PLAN COMMISSION AGENDA ITEM EXECUTIVE SUMMARY

Project Title/Address:	Meijer Outlot		
City Staff:	Ellen Johnson, Planner		
PUBLIC HEARING 5/8/18	X	MEETING 5/8/18	X

Staff Report

RE: Amendment to Special Use for Planned Unit Development & PUD Preliminary Plan –
 Meijer Outlot (Meijer PUD)

TREE REMOVAL PLAN

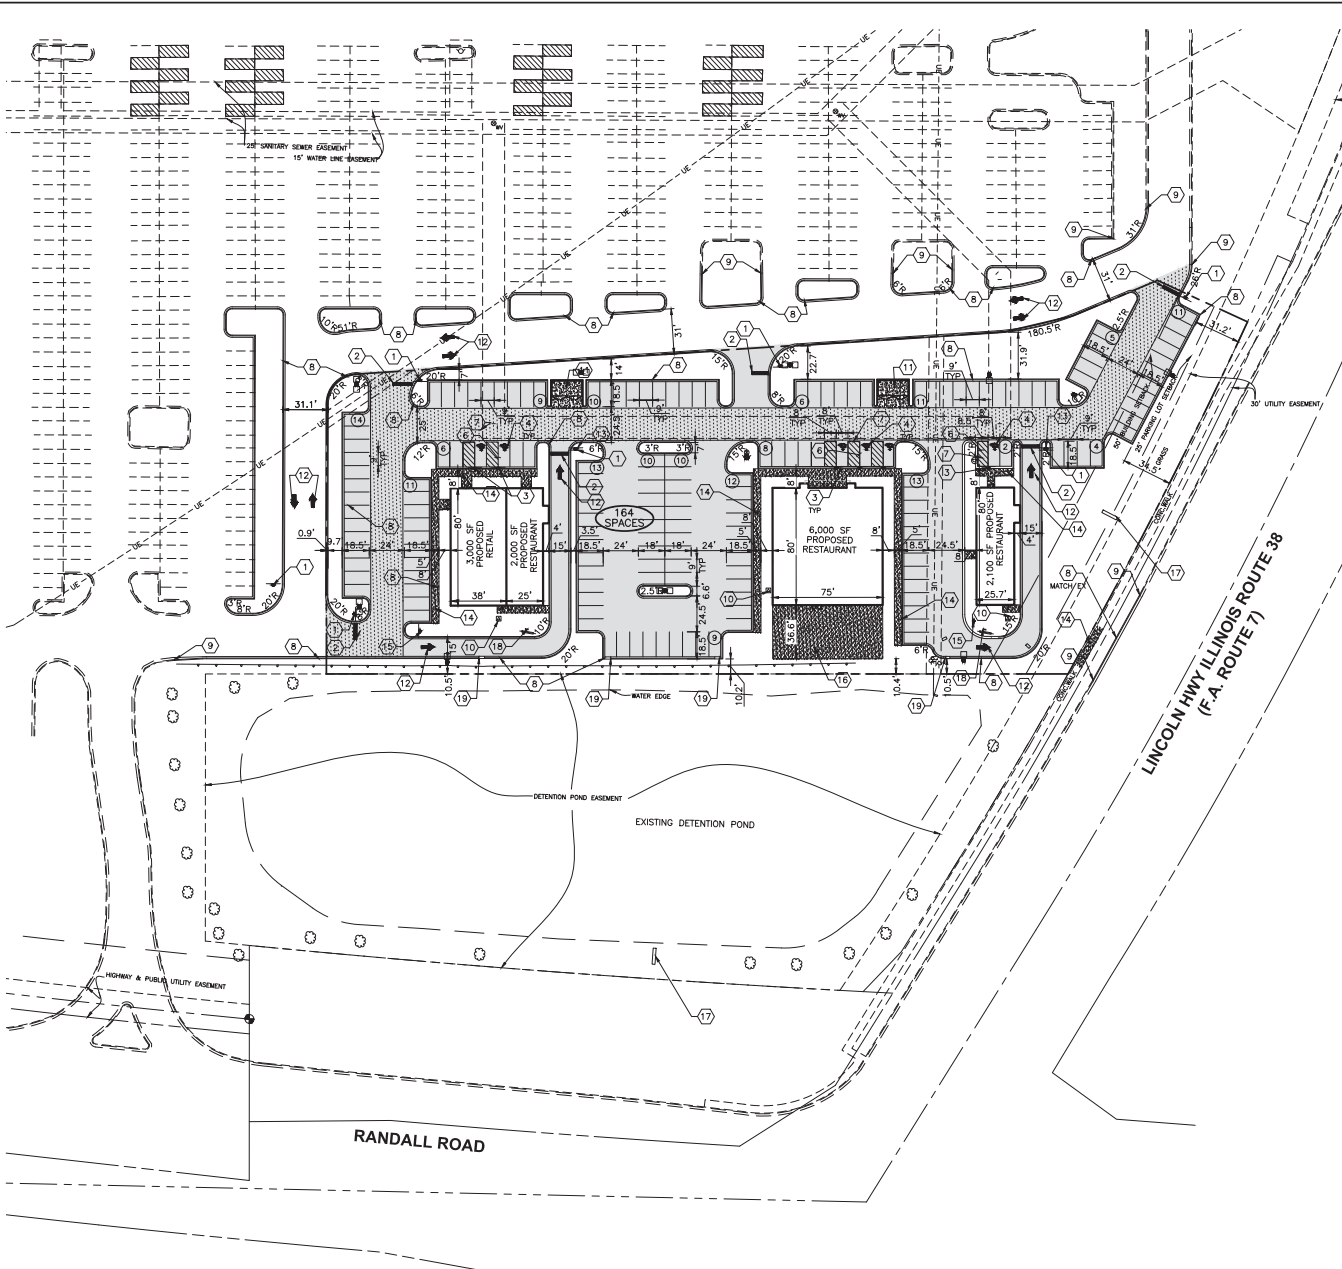
In order to increase visibility of the outlot development from Randall Rd., several trees are proposed to be removed around the adjacent detention basin. A Tree Removal Plan has been provided identifying trees that will be removed and preserved. All evergreen trees will be removed. All trees being preserved are deciduous. Meijer has provided a letter stating their consent to modify the landscaping around the detention basin, as it is on the Meijer property.

SITE PLAN

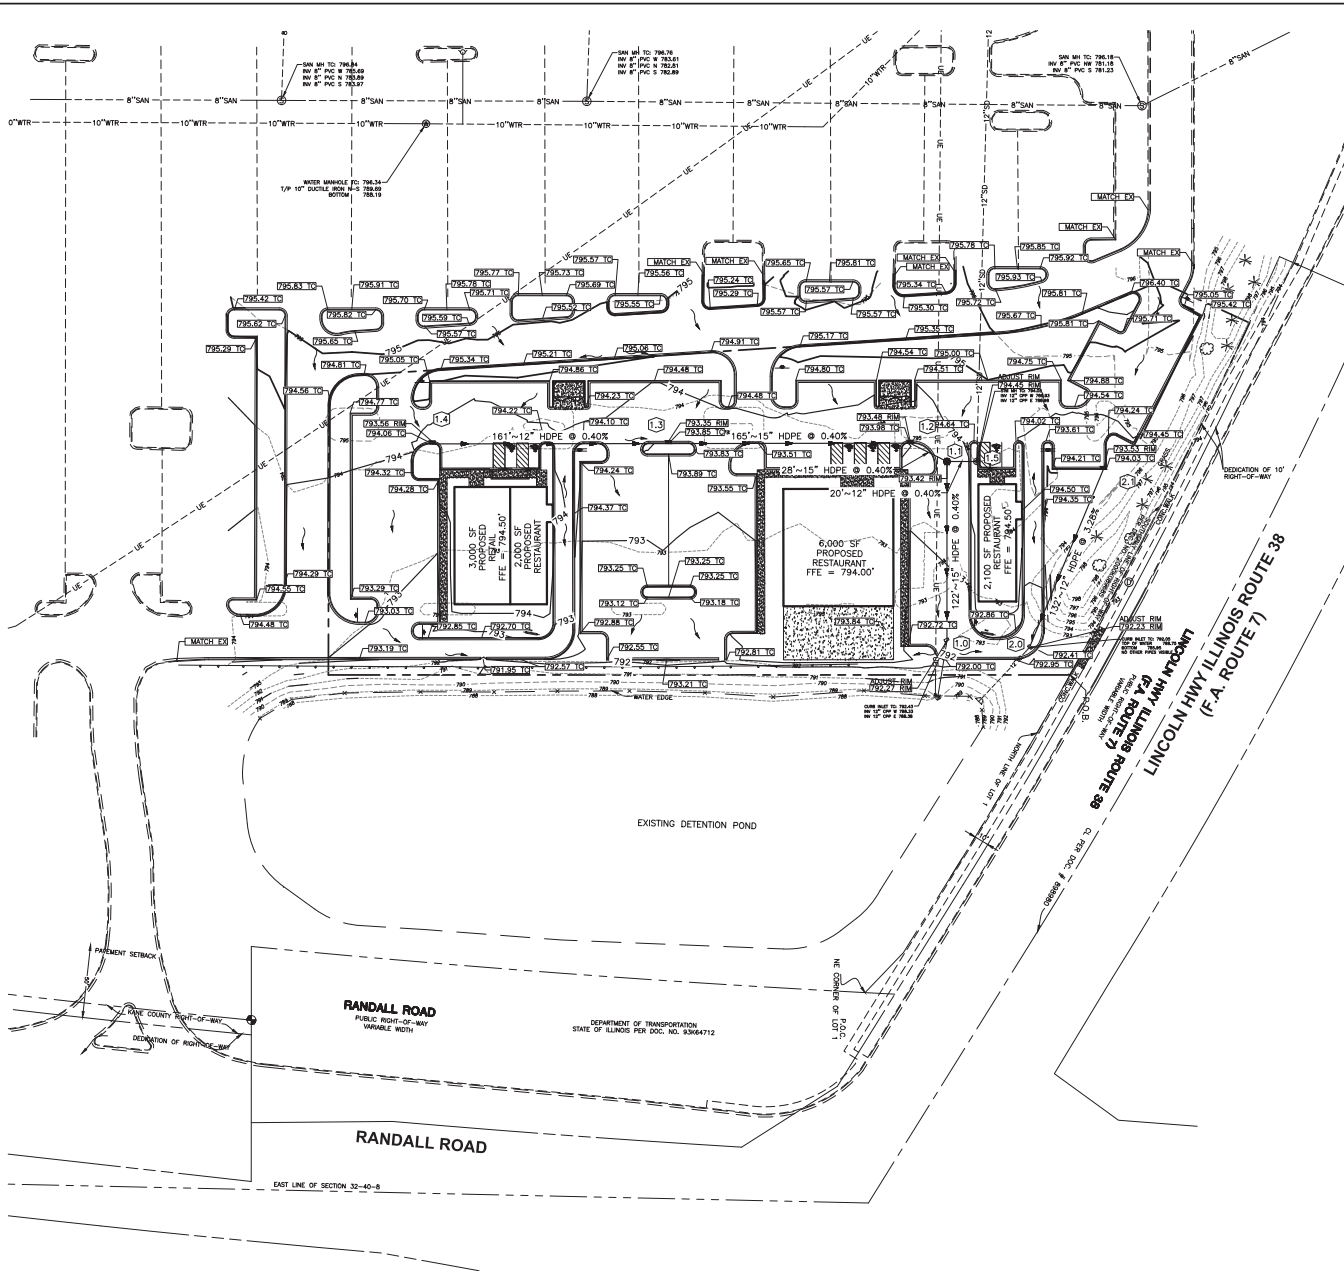
- Stacking spaces 9'x20' in size must be shown on the plans.

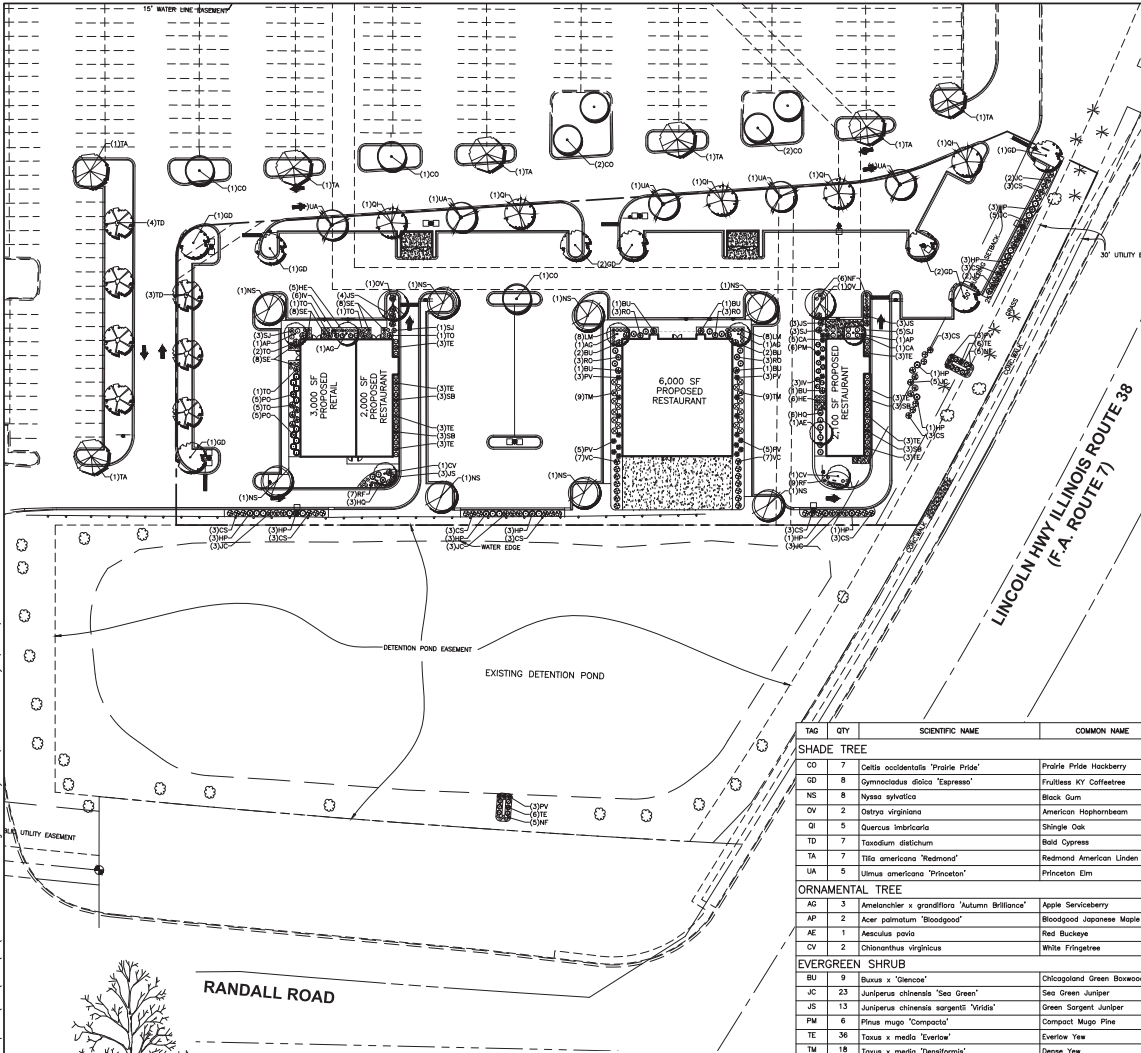
- 75% of the public street frontage must be planted with a combination of shrubs and perennials. This applies to the Lincoln Hwy. frontage. This requirement appears to be met with the proposed and existing landscaping. The existing landscaping should be identified on the plan to confirm.

- 10% of the interior area of the parking lot must be devoted to landscaping. This appears to be met. The applicant must calculate the percentage provided. If the 10% requirement is not met, additional landscape islands could be added due to the excess number of parking spaces.

- The amount of required plantings along the building foundation is calculated by dividing the total lineal feet of the building walls by 50. 2 trees and 20 shrubs/bushes/perennials are required per 50 ft. of wall. This requirement was calculated incorrectly on the landscape plan and half the required plantings are provided.
